# UNITED STATES PATENT AND TRADEMARK OFFICE

10/083,093

## Office Action Summary

## **DETAILED ACTION**

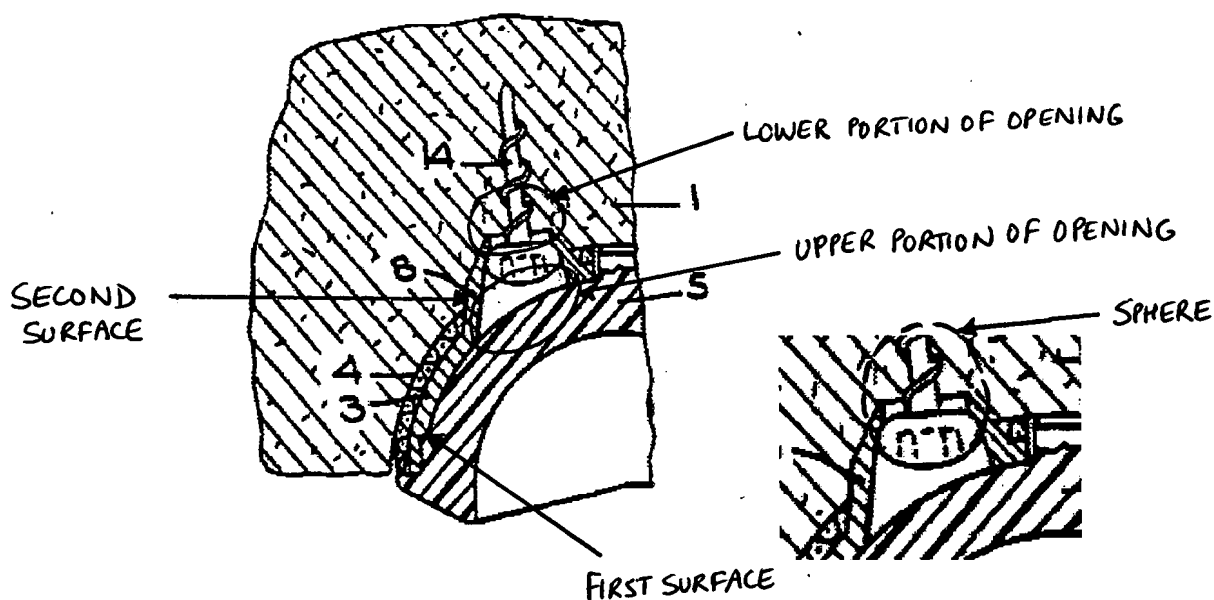
Regarding the limitation, “in a substantially fluid tight relationship” it is noted that the head of screw 14 forms a seal by the head of the screw abutting against the conical surface of the opening. Turning to Applicants’ specification to determine what constitutes a “substantially fluid-tight seal,” at page 23, line 21 and page 24, lines 1-2, Applicants’ disclose that a head of an insertion member should be received and locked in a screw hole to provide “at least a partial seal.” The screw 14 of Marchetti et al. forms “at least a partial seal” by being received and locked in the opening and thus fits in the opening in a “substantially fluid tight” relationship.

It is noted that the head of screw 14 abuts on the conical inner wall and thus provides a liquid-tight seal in that there is no opening or gap at the locking interface.

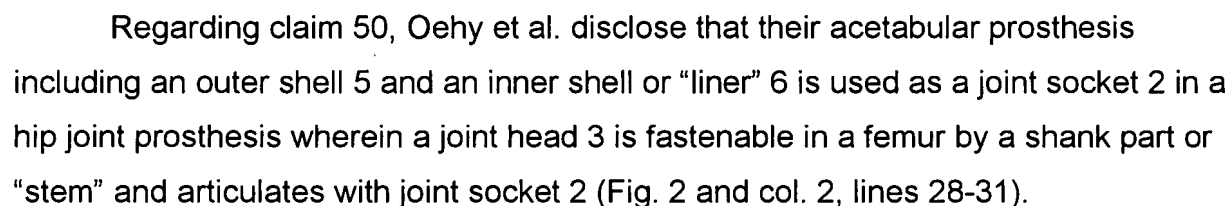
Oehy et al. disclose an acetabular shell or cup 5 having: a first surface, a second surface oriented toward bone; openings 12 extending from the first surface to the second surface wherein each opening 12 has an extended nonthreaded frustoconical taper section 25, a rounded section with a concave surface 25a beginning at a narrow end of the frustoconical section; each opening 12 capable of receiving any type of fastening element or insertion member; an insertion member 14 having a head with a spherical undersurfaces 14a seatable in surface 25a in a plurality of angular positions (Figs. 1-2, col. 2, lines 45-67, col. 3 and col. 4, lines 1-6). See marked up Fig. 2 below.
